CALL NO. 200
CONTRACT ID NO.
131212 Addendum # 2

Subject: Marshall Trigg County, 121GR13D012 - NHPP 0801 (098)
Letting December 20, 2013

- (1) Revised - Plan Sheets - R2, S2, S134, S183, S184A, S184B, S187, S192, S194, S206, S207, S207A, S207B, S208, S208A, S208B, S209, S209A, S210, S211, S212, S213, S216, S217, S260, S261, S274
- (2) Revised - Cover Page - PAGE 1 of 403
- (3) Revised - Completion Dates - Page 4 of 403
- (4) Revised - Multiple Notes - Various Pages
- (5) Revised - Bid Items - Page 397-403 of 403
- (6) Delete - Pages 27thru44, 216thru233, 207thru215, 234thru238 of 403

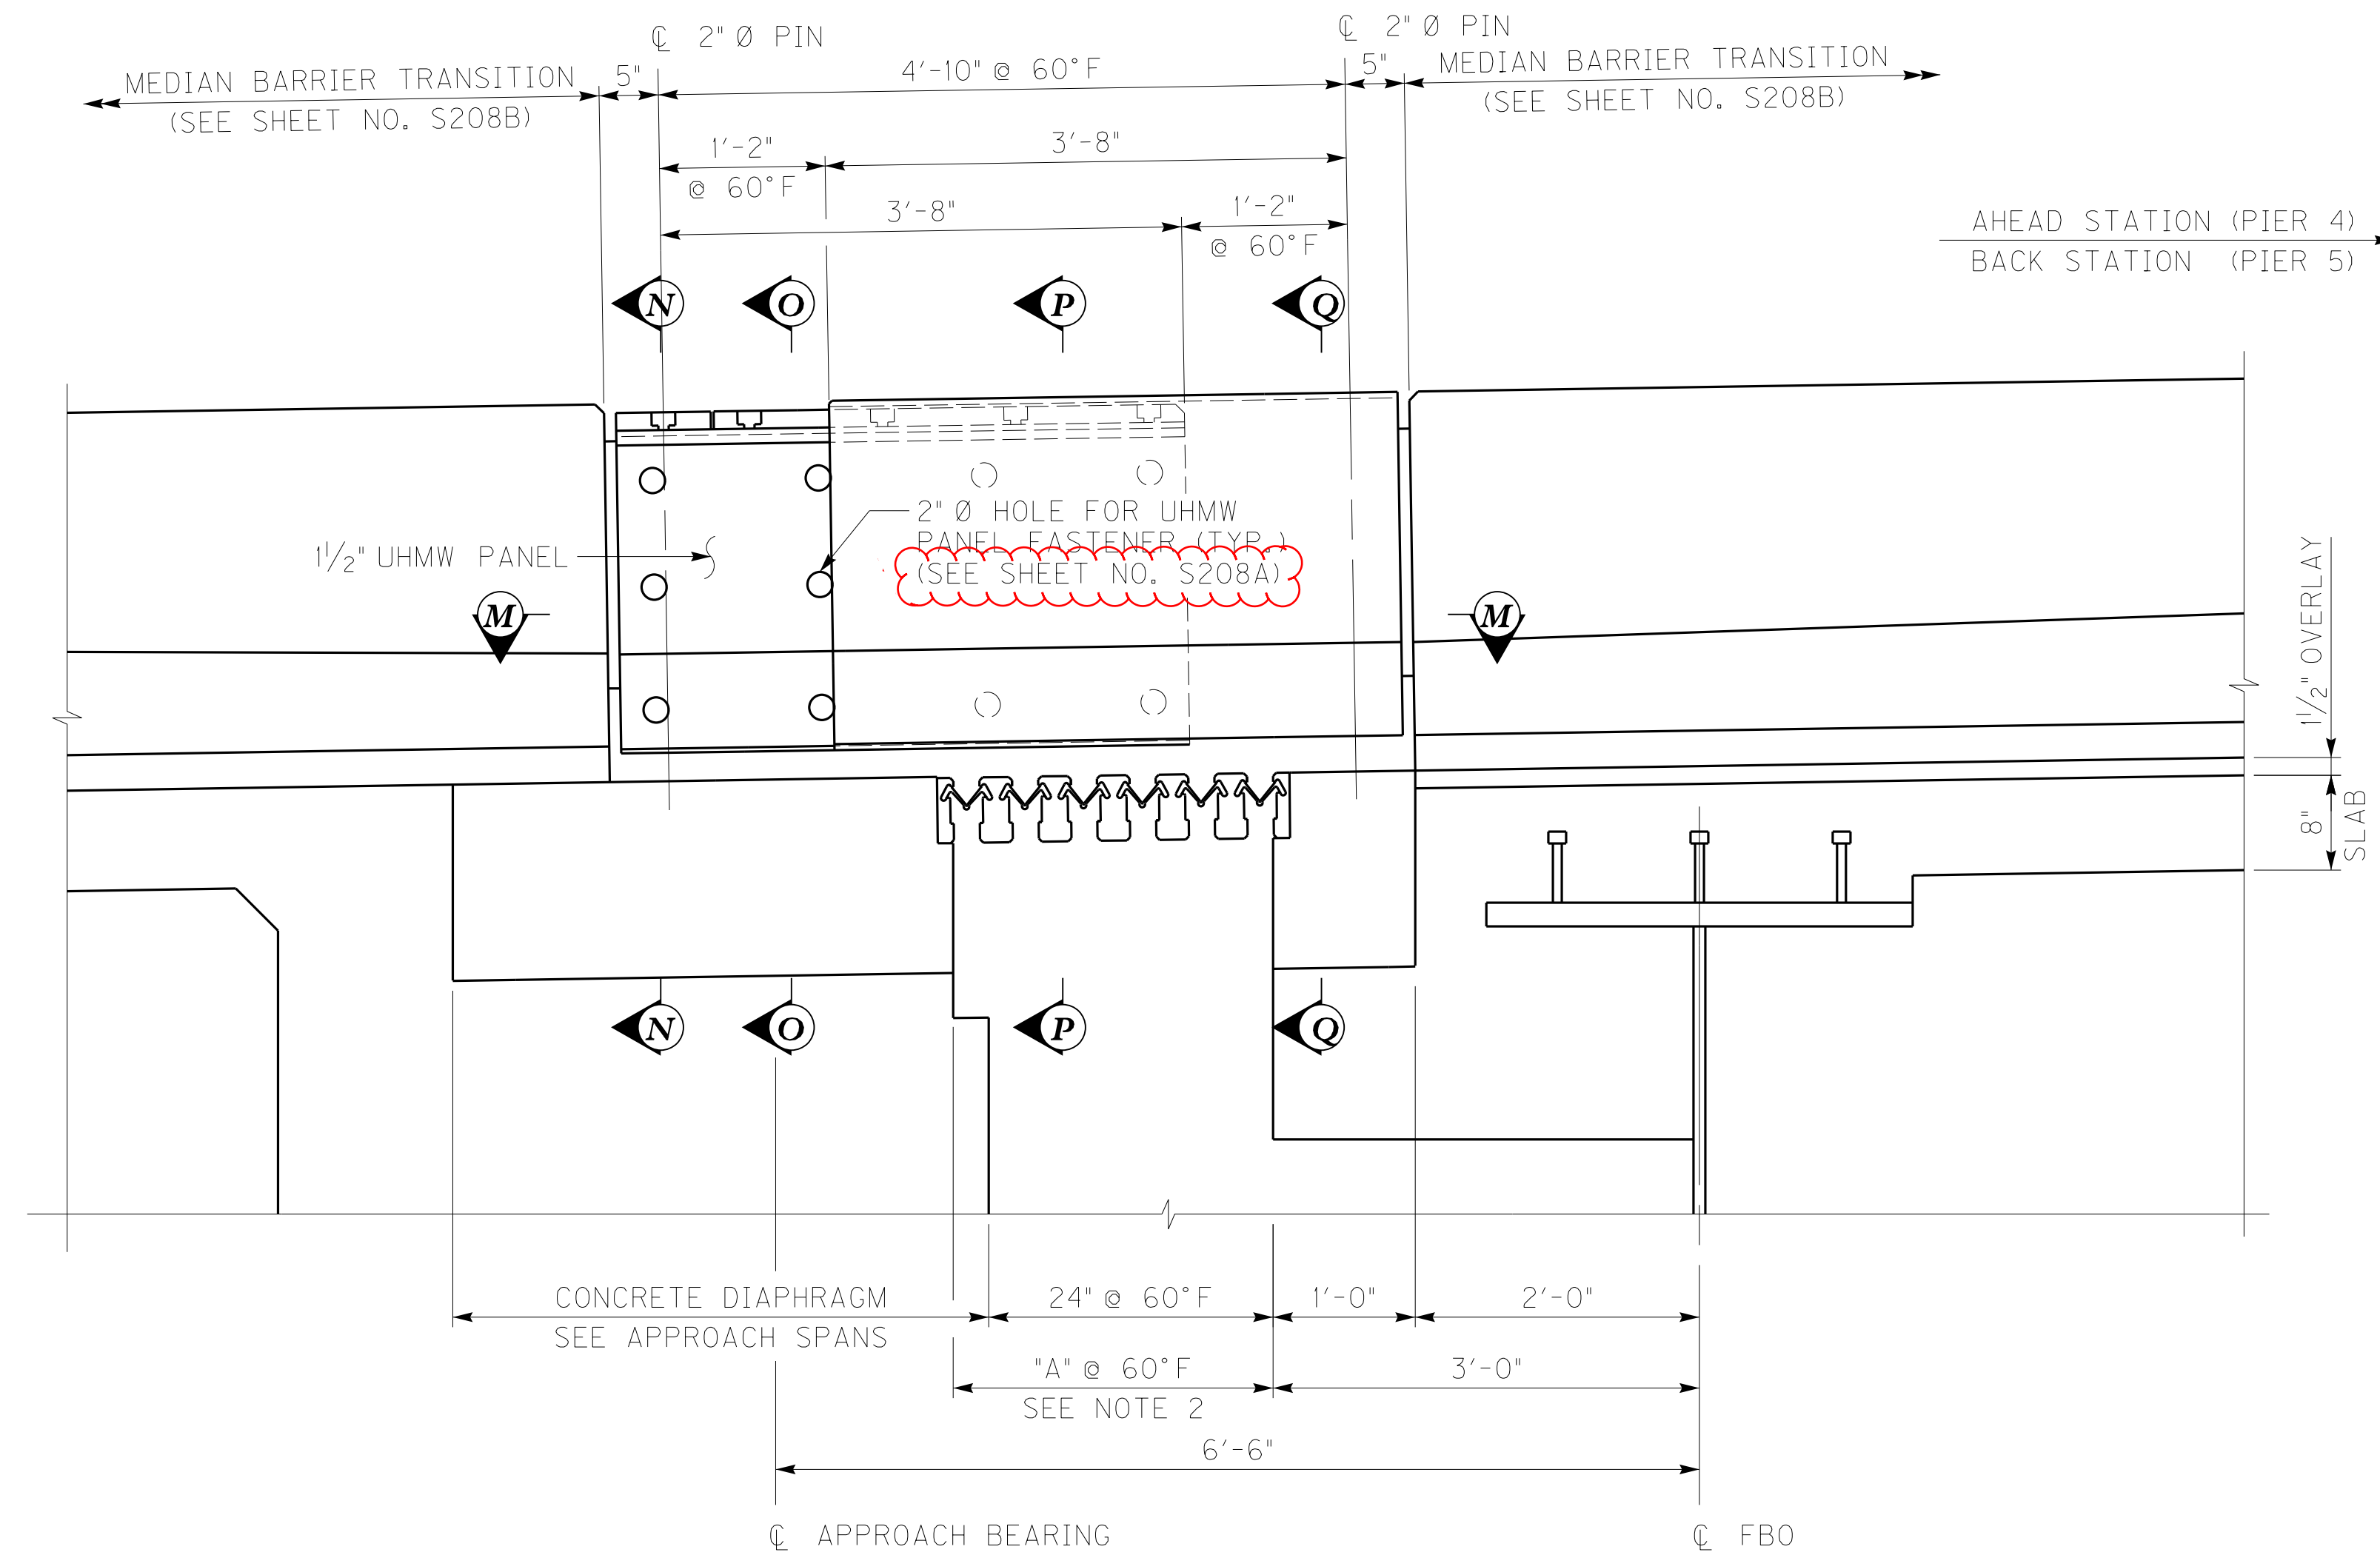
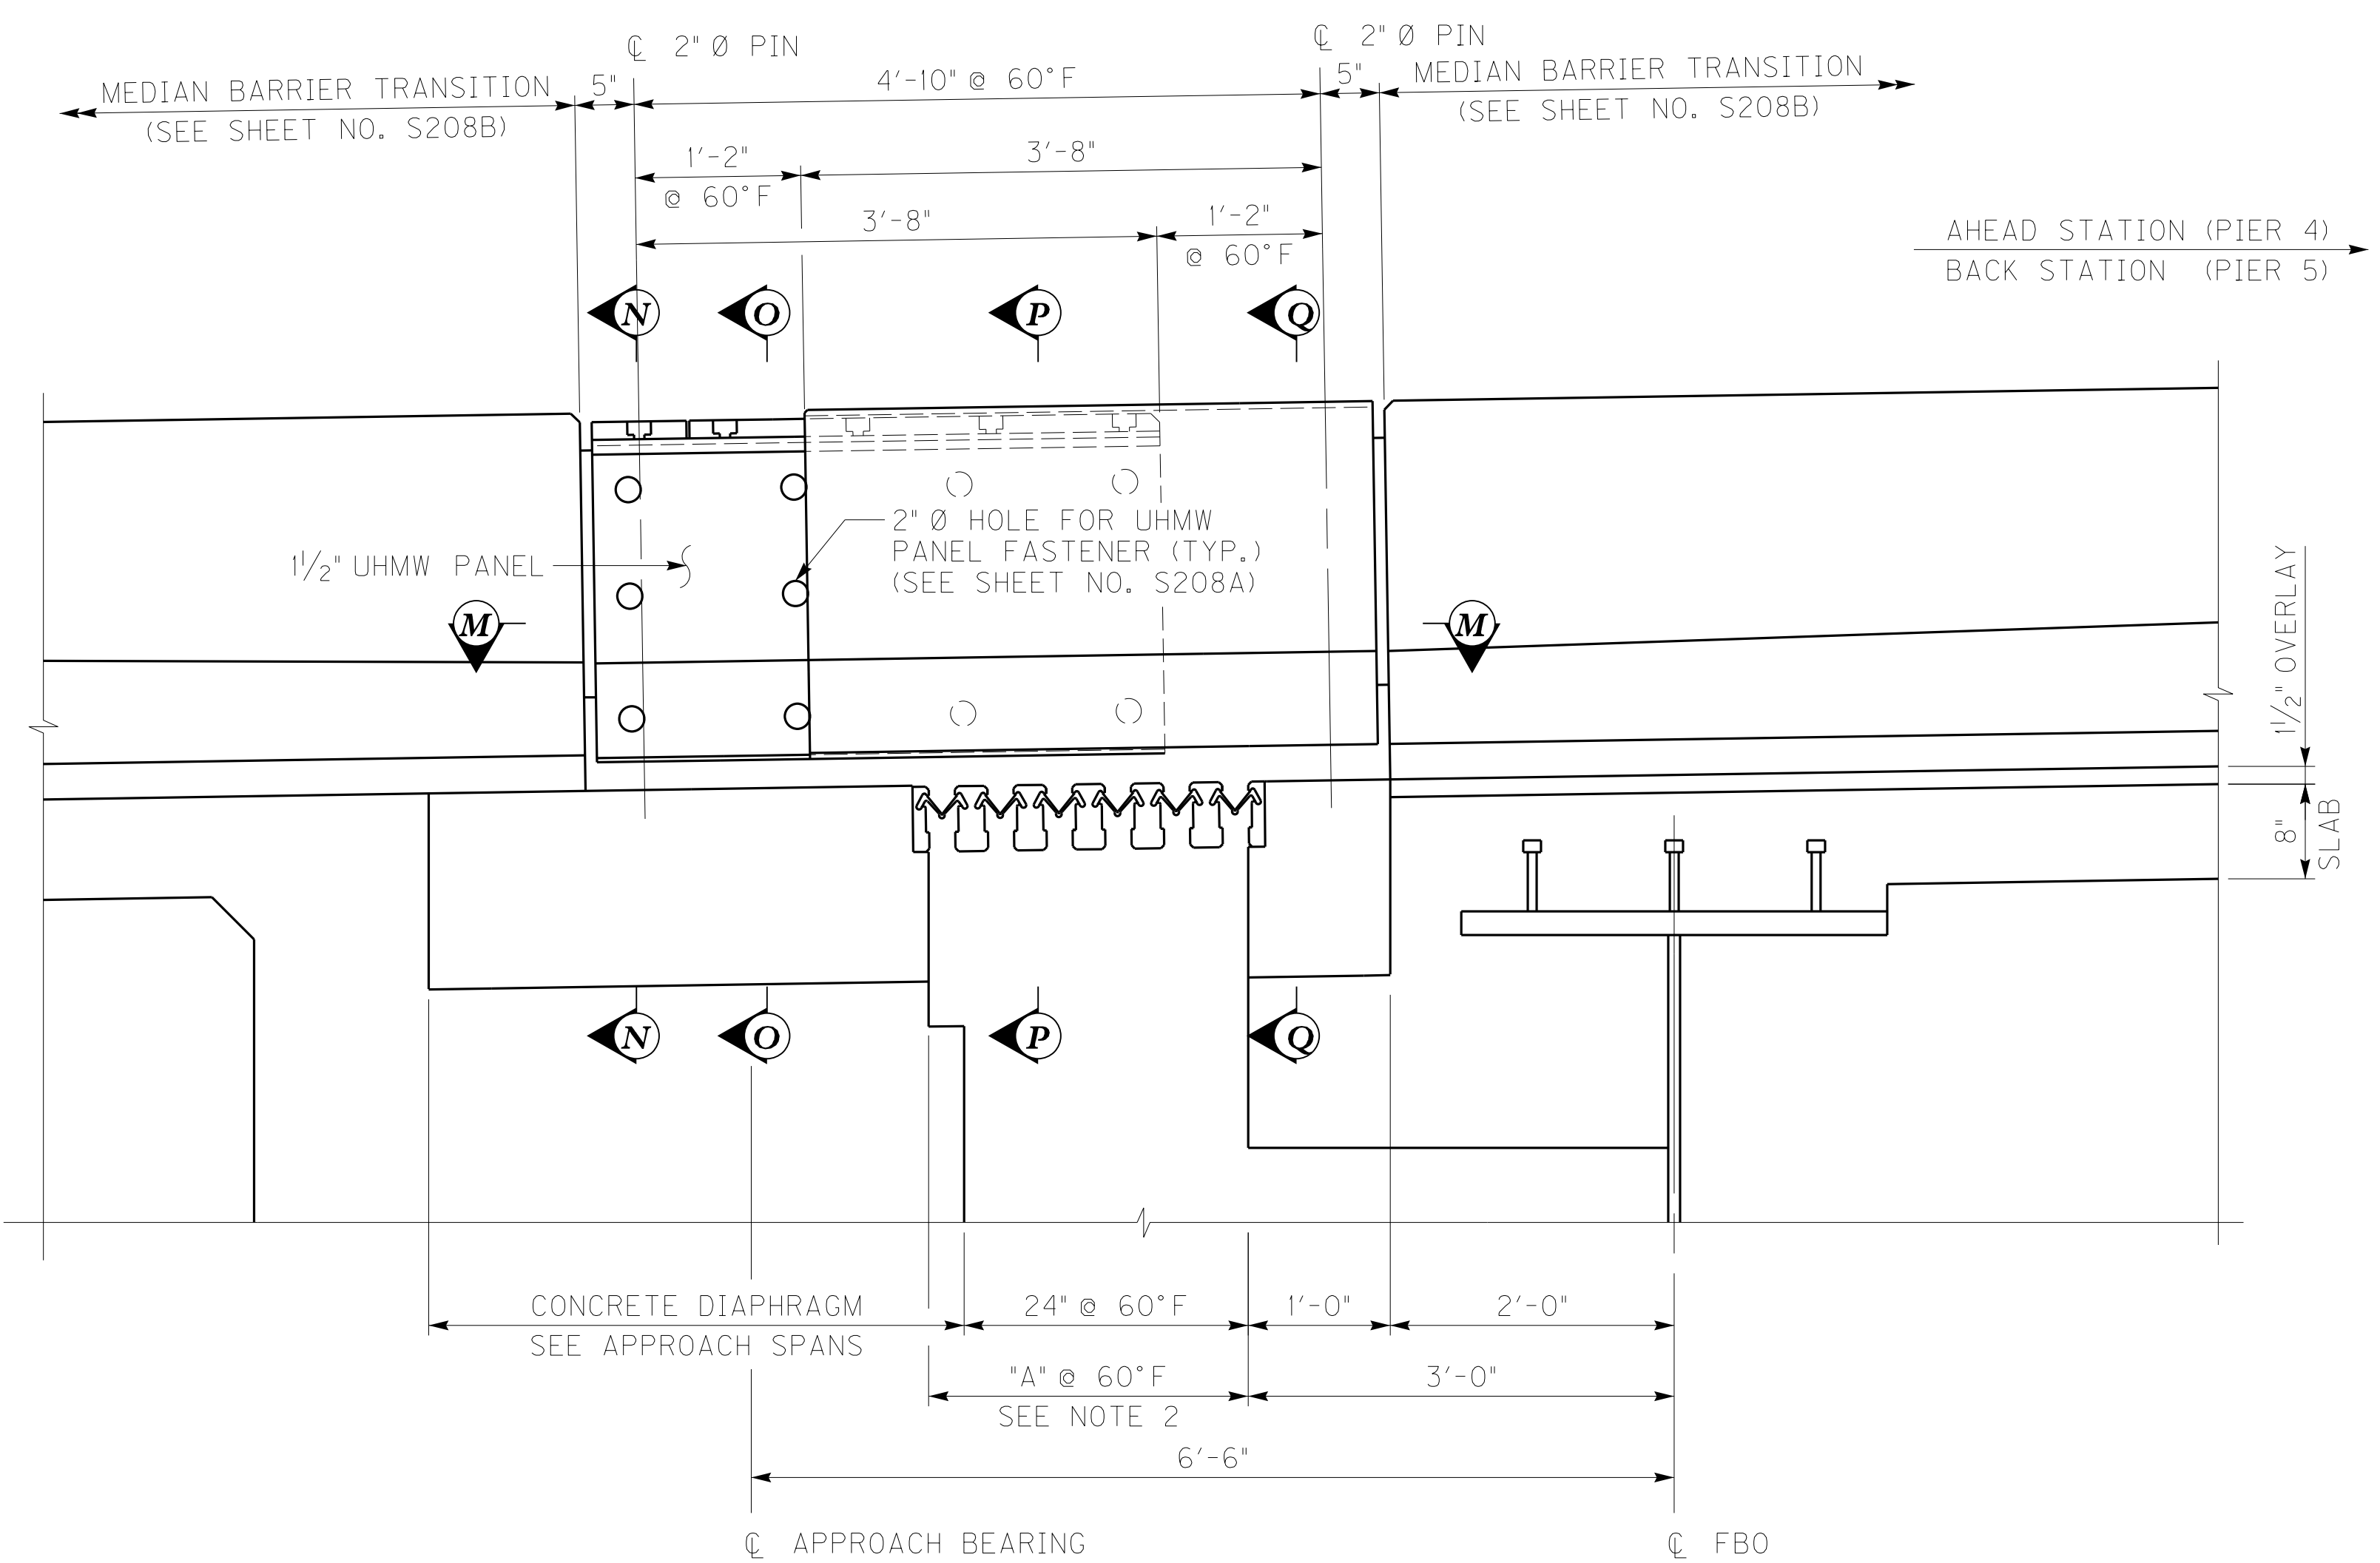
ADD CURB, ADD SHEET REF.		11/25/13
REVISION		DATE
DATE: NOVEMBER 15, 2013	CHECKED BY	
DESIGNED BY: DMB	TJT	
DETAILED BY: MJD	DMB	
Commonwealth of Kentucky DEPARTMENT OF HIGHWAYS		
COUNTY MARSHALL / TRIGG		
ROUTE US68	CROSSING KENTUCKY LAKE	
MODULAR EXP. JOINT DETAILS - 4		
ITEM NUMBER	PREPARED BY	SHEET NO.
01-180.70	Baker	S208
	MICHAEL BAKER JR. INC. 9750 ORMSBY STATION ROAD SUITE 210 LOUISVILLE, KY 40223	DRAWING NO. 24686
